DECLARATION STATEMENT - RECORD OF DECISION

Buffalo Color Site  
Buffalo, New York  
Site No. 9-15-012 A&B

**RECORD OF DECISION**

New York State Department of Environmental Conservation  
Responsiveness Summary  
for  
Proposed Remedial Action Plan  
Buffalo Color Sites  
Site Nos. 9-15-012 A&B  
Buffalo, New York

# ALTERNATIVE 6c SCHEMATIC

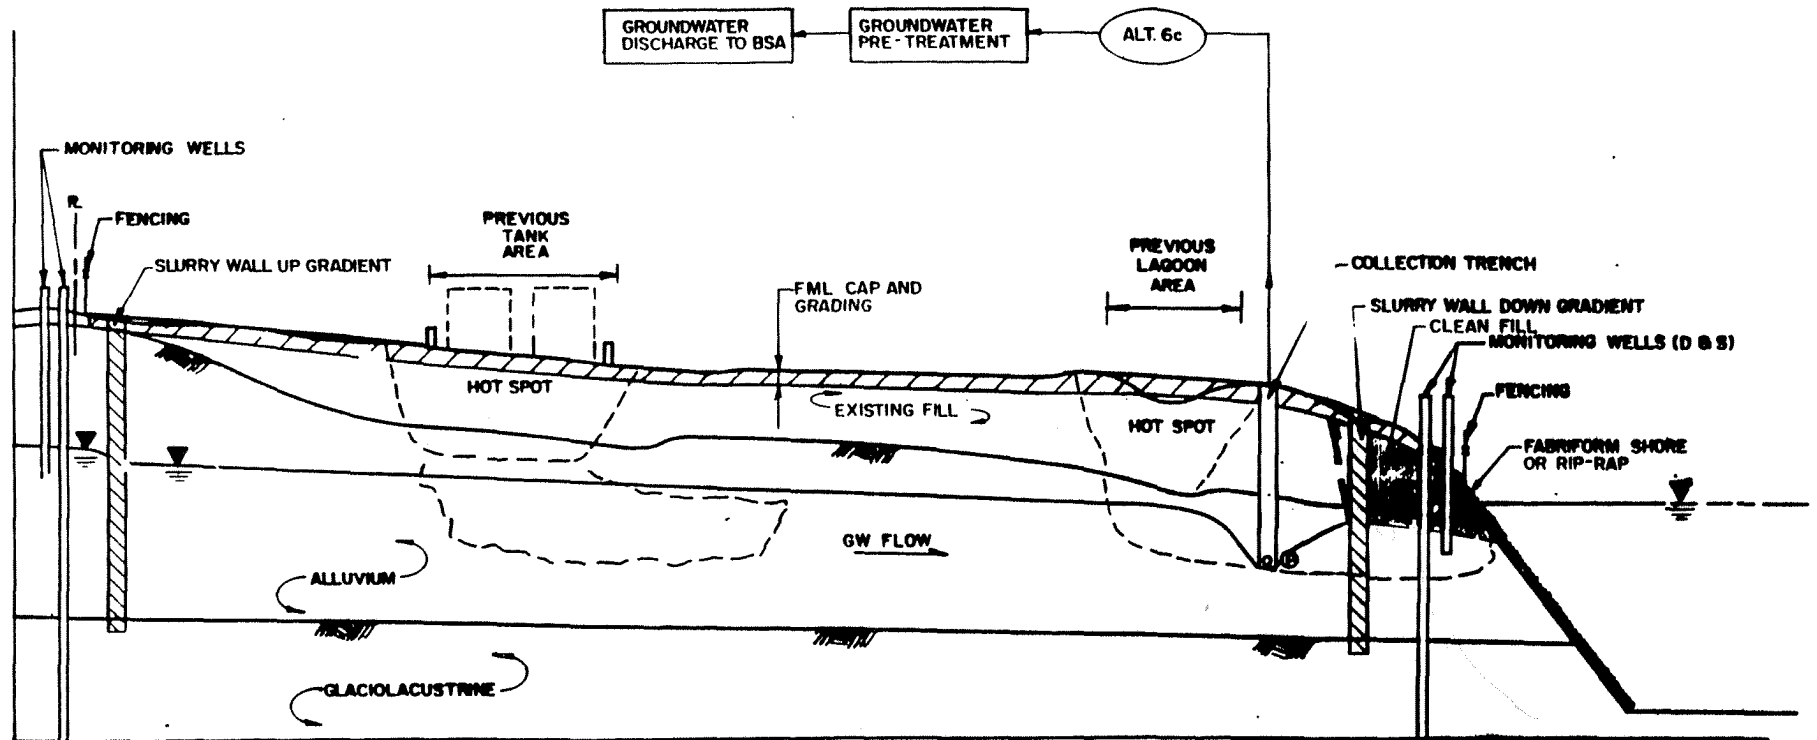
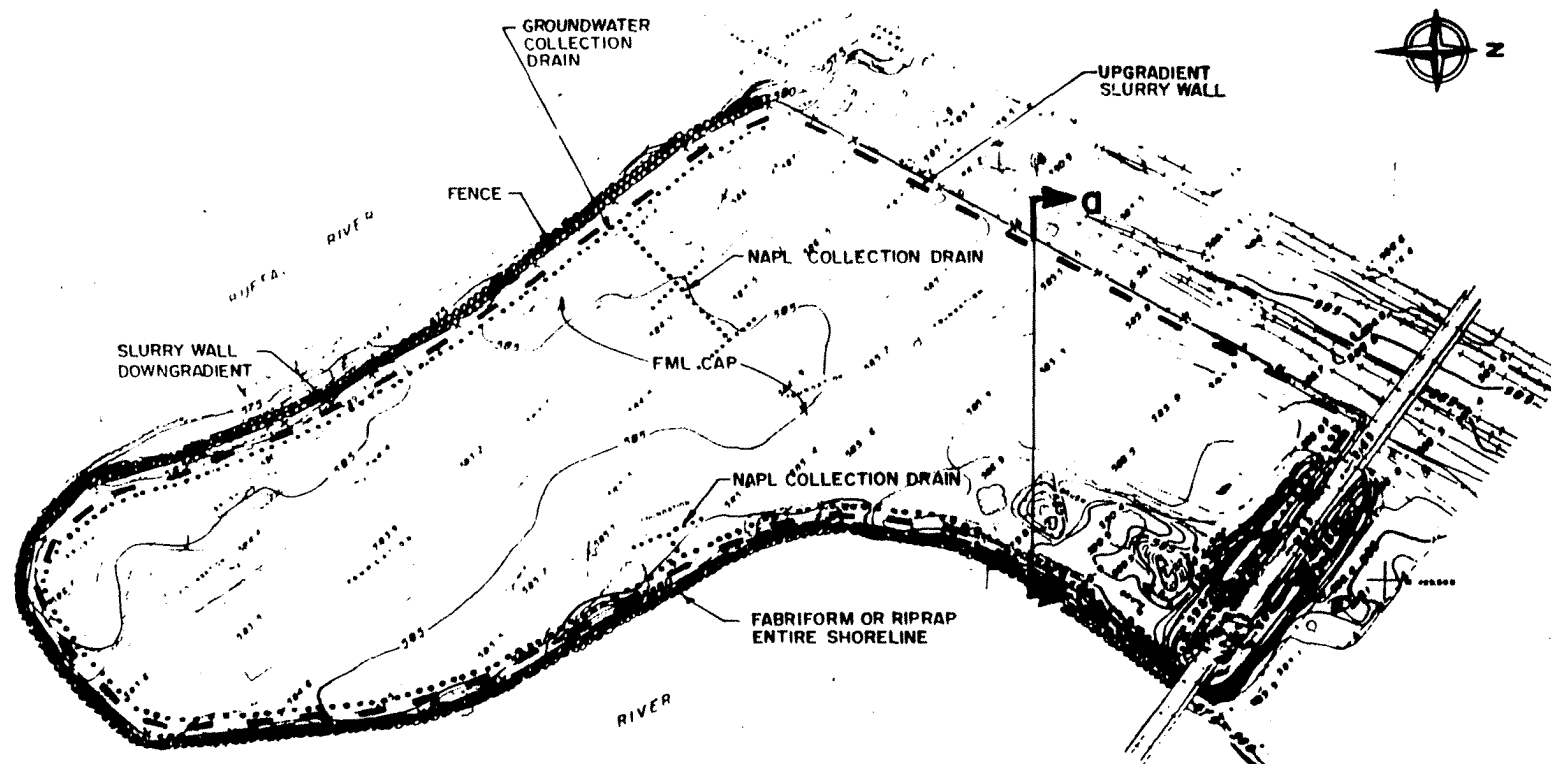
Question: Referring to Alternative 6c schematic: In the proposed remedial alternative when you install the slurry wall, the waste/sediment outside the wall (along the river bank) will be taken out and put back on the other side of the wall. Why? If you are going to take it out, get rid of it. Neutralize it completely. Don't throw it back in. Why dump it into a larger area and make the larger area more contaminated?

Answer: Due to construction difficulties the slurry wall cannot be installed right against the water. Installing the slurry wall approximately 20 to 30 feet inward resulted in leaving some contaminated soil outside the containment system which was not acceptable to the Department. Therefore, the original proposal was revised to address this problem. The revised proposal not only addressed the contaminated soil outside the slurry wall, but the sediments on the bank of the river. This offered an additional advantage of installing the slurry wall in clean fill rather than against the waste material. The revised proposal calls for the excavation of the waste/sediments from the proposed location of the slurry wall upto the River bank, placing the excavated waste within the containment and replacing the excavated area with clean fill. The slurry wall then will be installed in the clean fill. The sediments are less contaminated as compared to the waste material. Therefore, placing the sediments in the
